## **STAFF REPORT**

PLANNING COMMISSION

DATE: 1/22/24

**AGENDA ITEM:** PUBLIC HEARING - Preliminary Plat/Planned Unit Development request by At Home Apartments

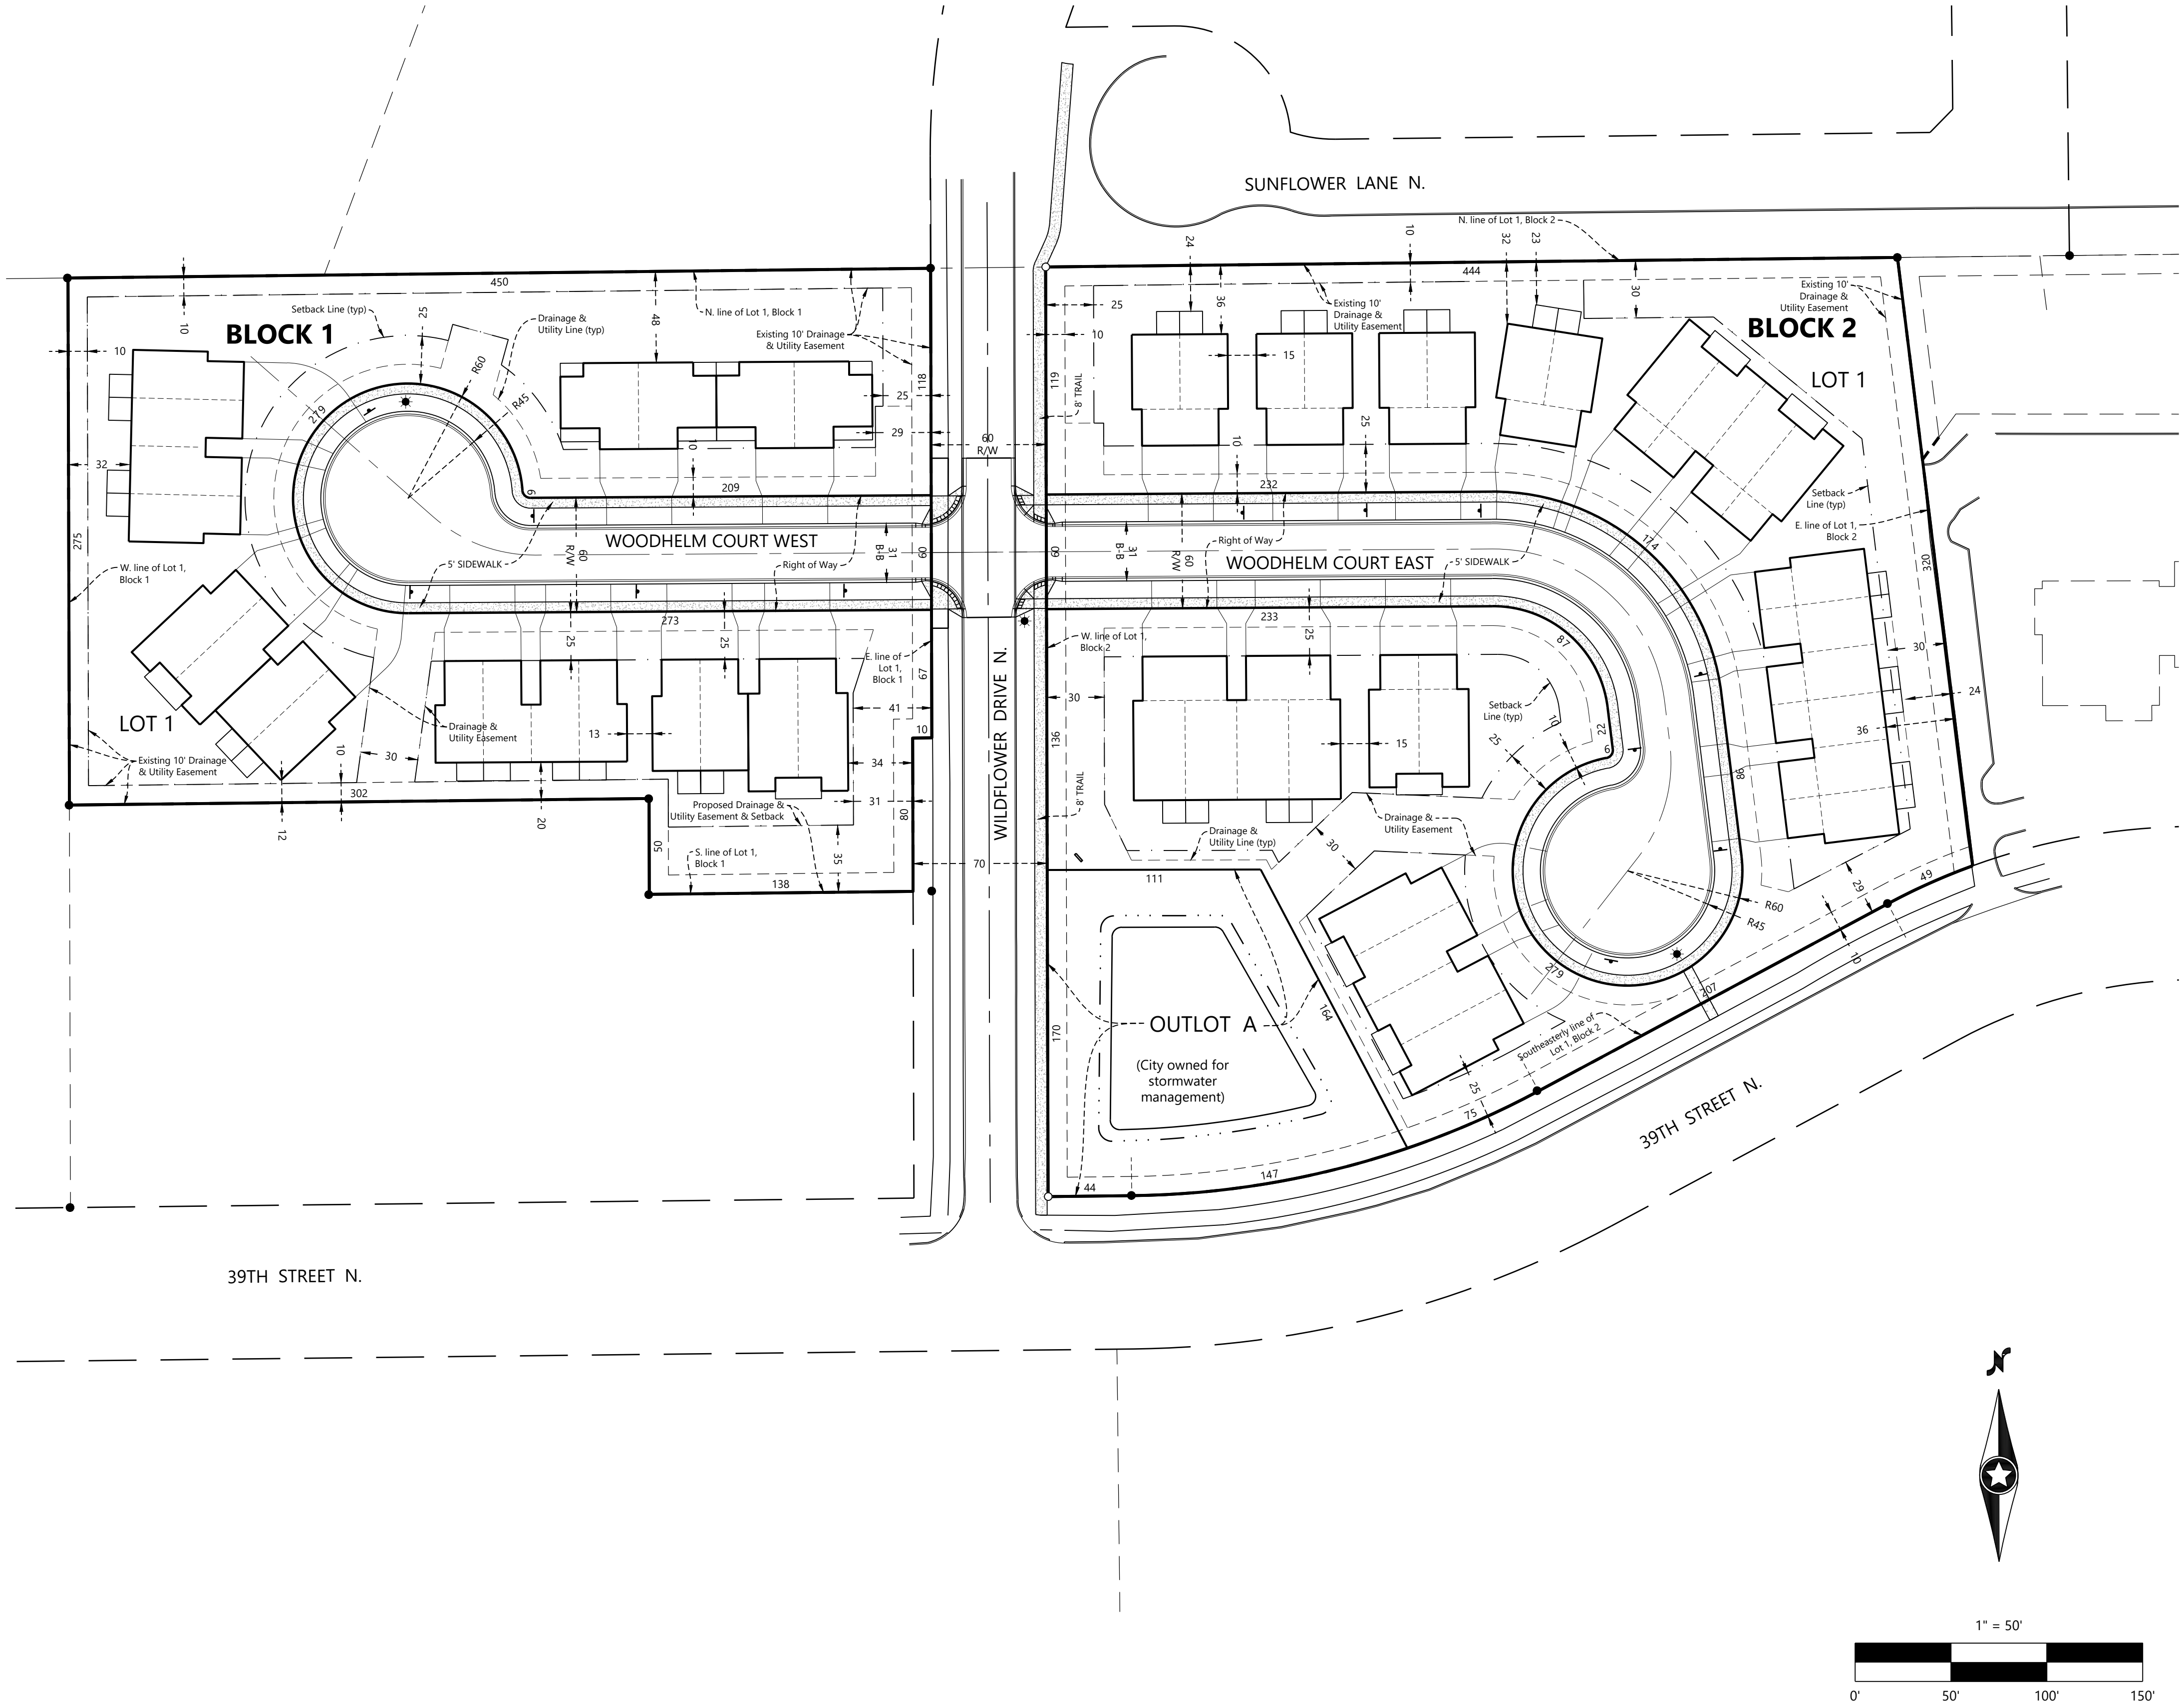
**Comment 5:** Road width reduction – Staff have discussed the proposed road width reduction (32'-28') as requested by the Applicant and planning commission. Staff are willing to consider and possibly support the width reduction but with the following items addressed: (a) All buildings, including twin homes, must be sprinkled; (b) A parking diagram should be submitted to detail where parking will be located on-street if parking is only allowed on one side of the street. I think detailing how much parking would be lost going from both to one side of the street parking would also be helpful; (c) Areas where additional parking can be located for visitor stalls on the site should be identified. One such area appears to be in the area east of Block 2, unit 23; (d) An approval may be conditioned upon the addition of language to the eventual leases requiring that garage areas be used for parking of vehicles (as opposed to storage, as is often the case) such that the driveways remain open for visitors to park. This would be intended to reducing parking issues during peak utilization periods such as with holidays and events.

- a. The townhome structures are required to have sprinklers as per the state building code, and the Applicant's plans already include a sprinkler system for these units. Twin homes are not mandated to have a sprinkler system under the state building code. The Applicant wishes to express its concerns about the financial impact this requirement would have on the total project costs. In light of this, the Applicant is seeking a thorough understanding of the rationale behind this requirement and its connection to the Applicant's request to reduce the street width to 28' which is in alignment with other neighborhood streets.

- b. Each unit provides ample parking space for four vehicles – two stall garages and a driveway capable of accommodating two additional parked cars. This results in a total of 192 parking spaces for 48 units, surpassing the city code requirements. The Applicant is confident that even if the city decides to limit on-street parking to one side of the street, there will be no parking shortage. It's noteworthy that despite being classified as a multifamily housing community, the housing product type is designed to resemble a single-family home community, complete with two-stall garages and driveways, aligning with the resident behavior of a twin and town home community and a single-family home community.

OFF-SITE TOPSOIL  
STOCKPILE PLAN

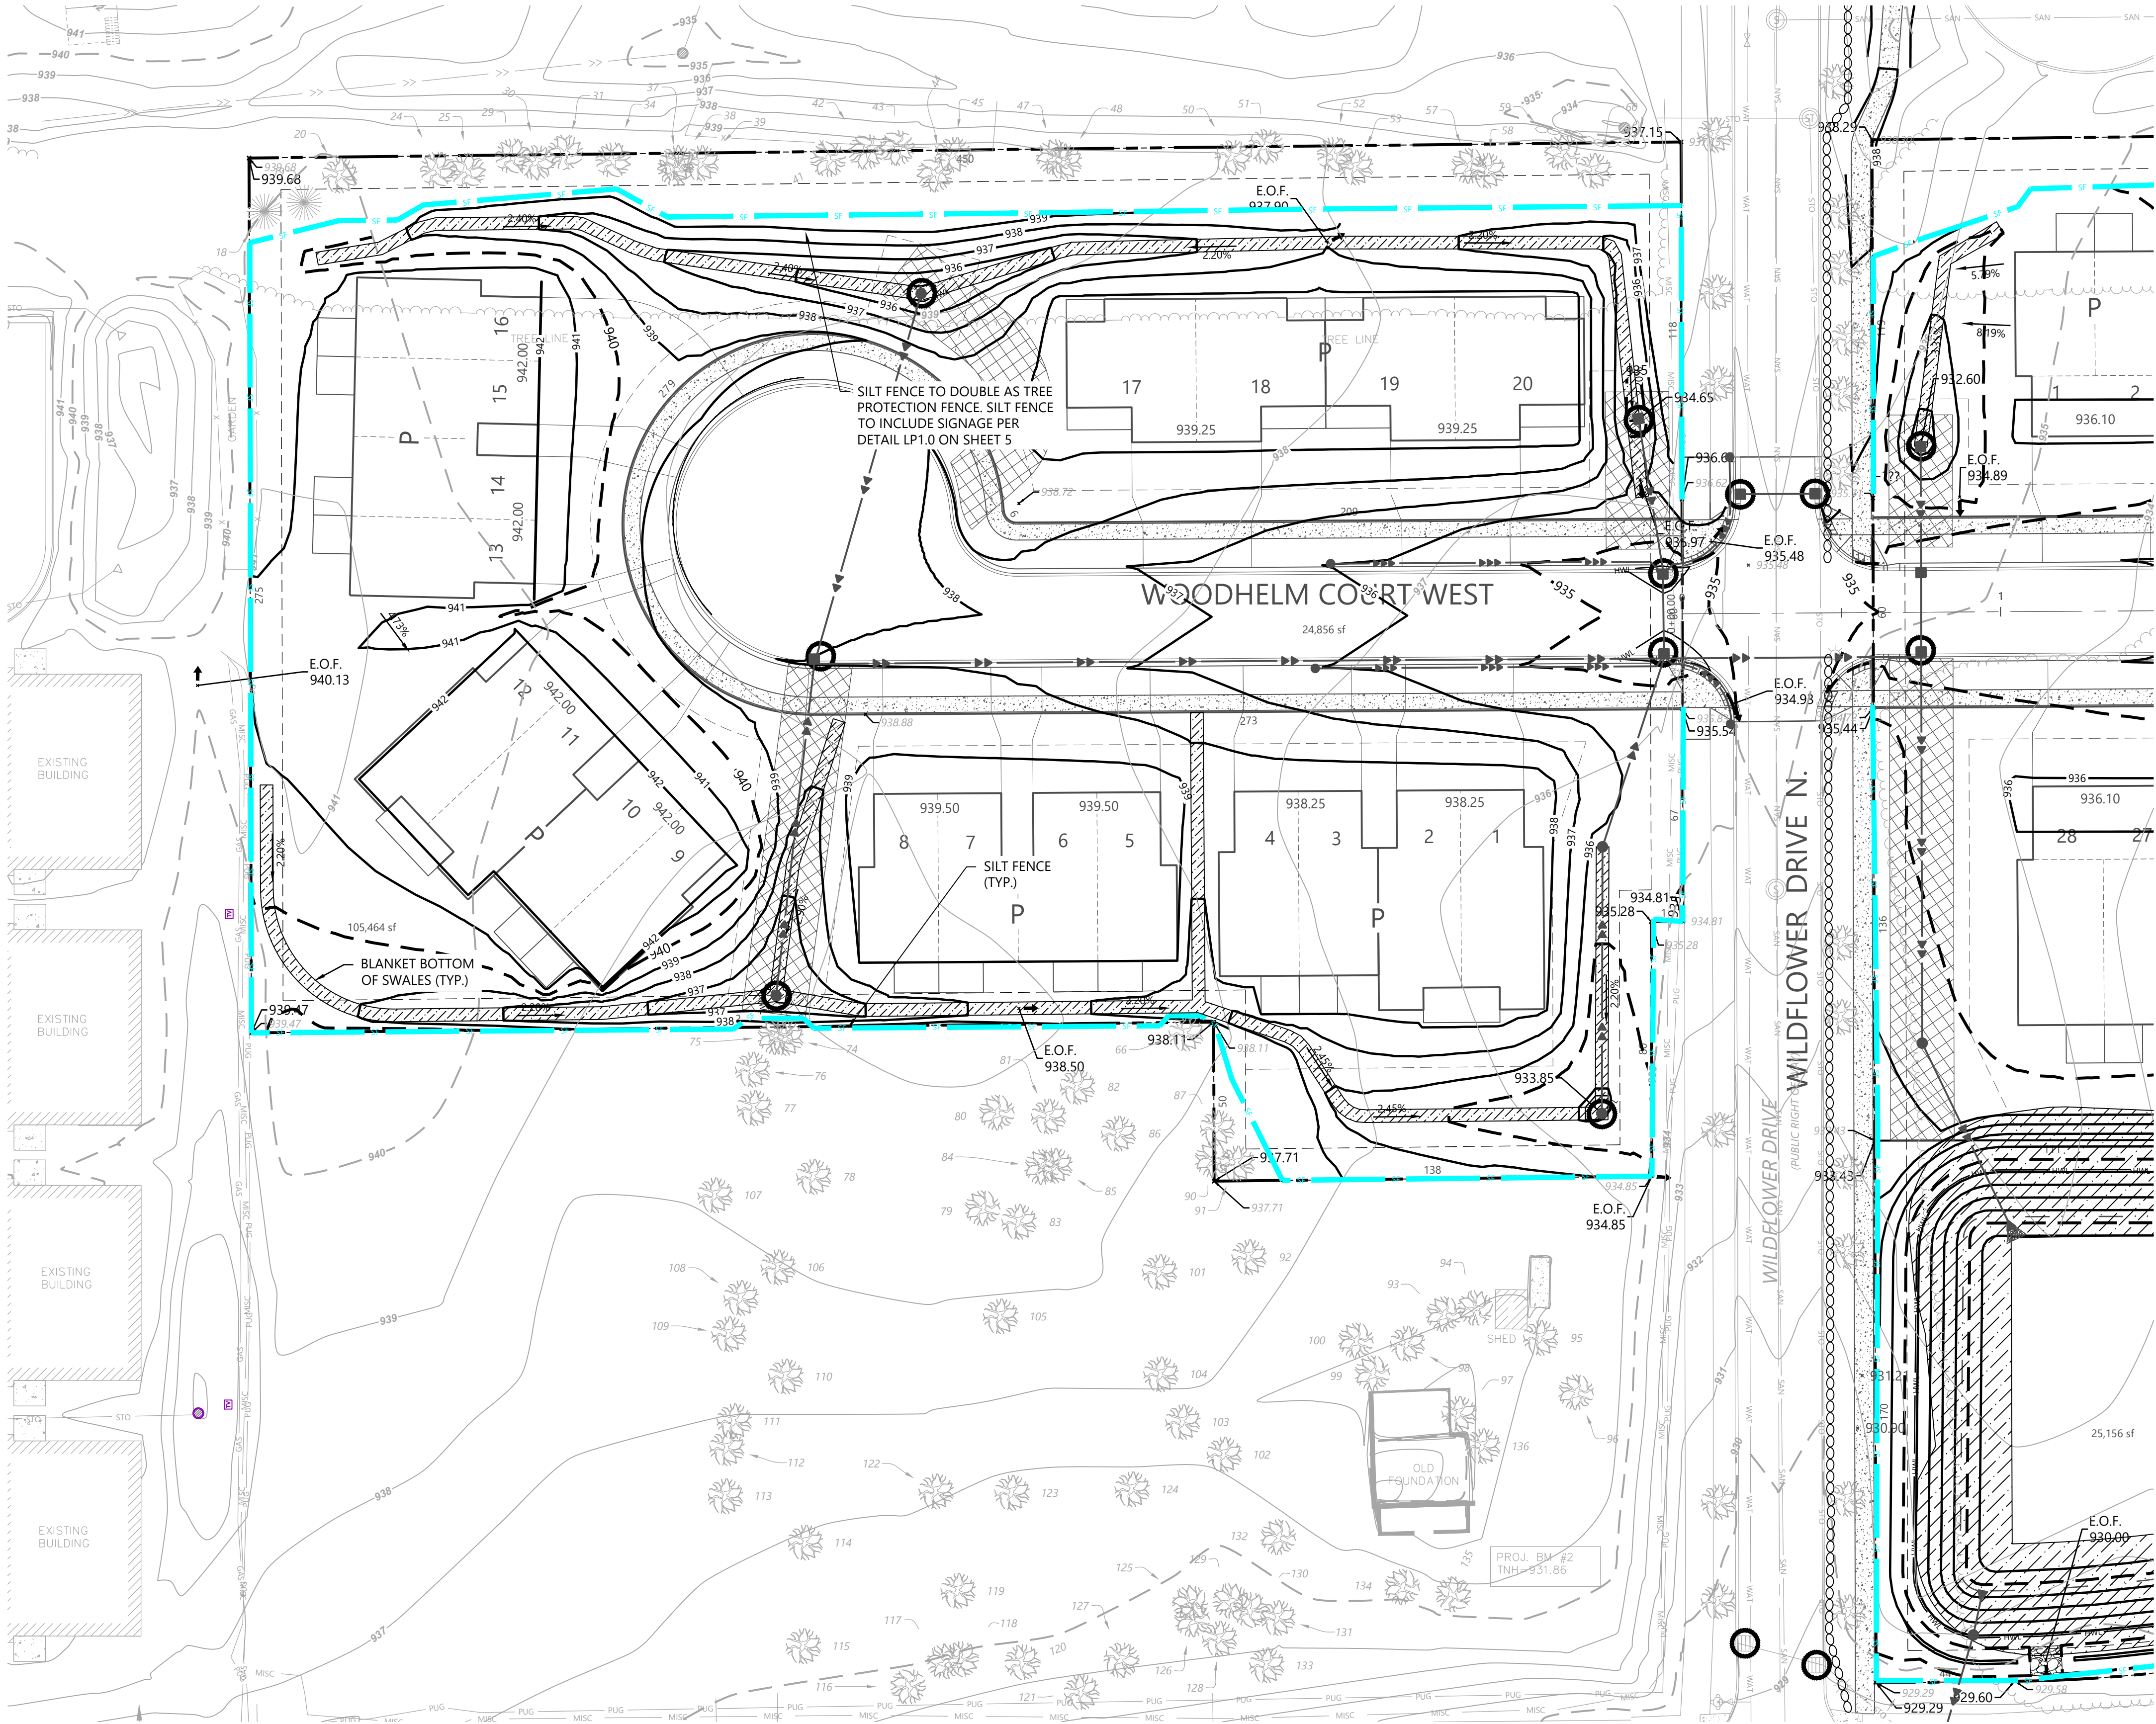
- Response: Hatches have been adjusted for easier identification. Notes have also been added for further clarification. Please see Sheet 34.
- The landscape plan must include a topsoil preservation plan that identifies a stockpile location and other requirements per 101.12.480(a) (9) and (h).

- Response: Applicant previously discussed with city staff its plan to store topsoil on another property owned by the Applicant and located near the Subject Parcels. Please see Sheet 21 for additional details.
